# Certificate of Appropriateness

1315 Rutledge St

January 11, 2021

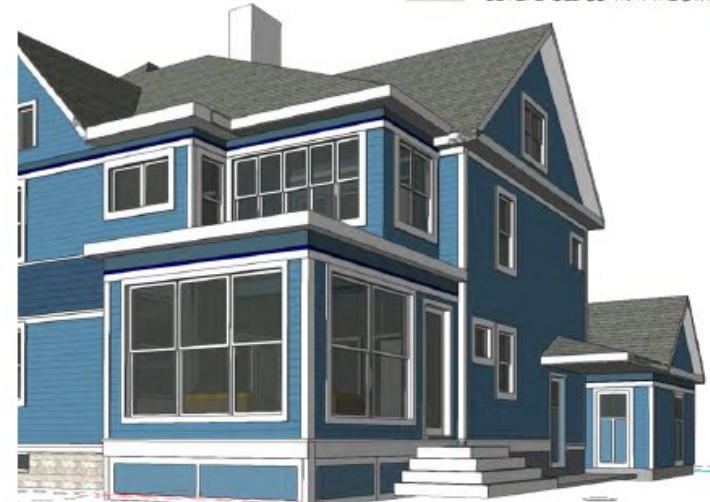
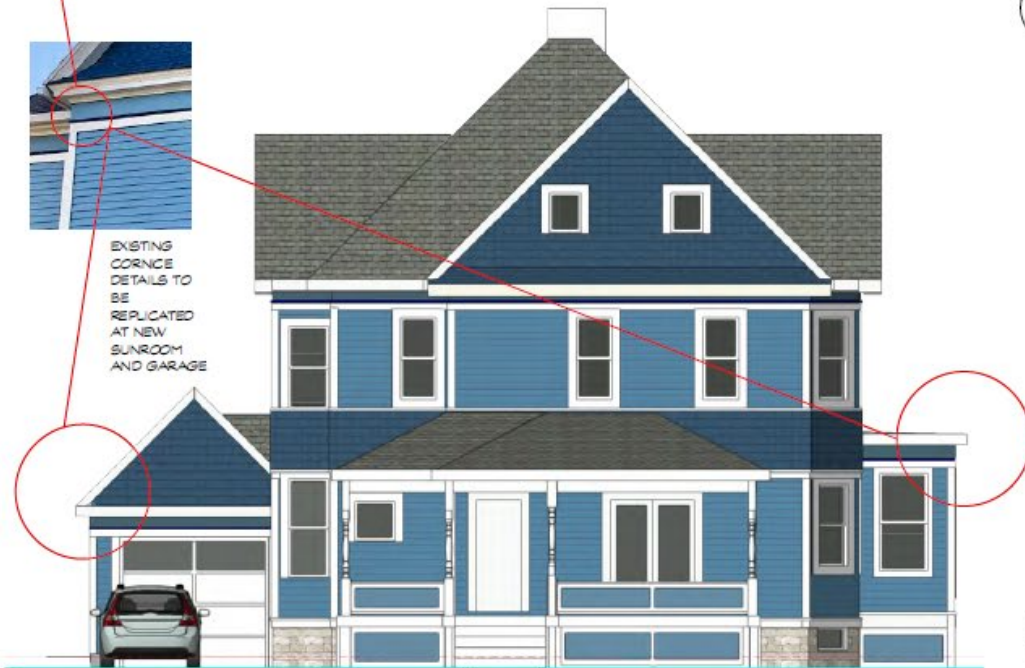
Staff believes that the standards for granting a Certificate of Appropriateness are met and recommends the Landmarks Commission approve the request as proposed.
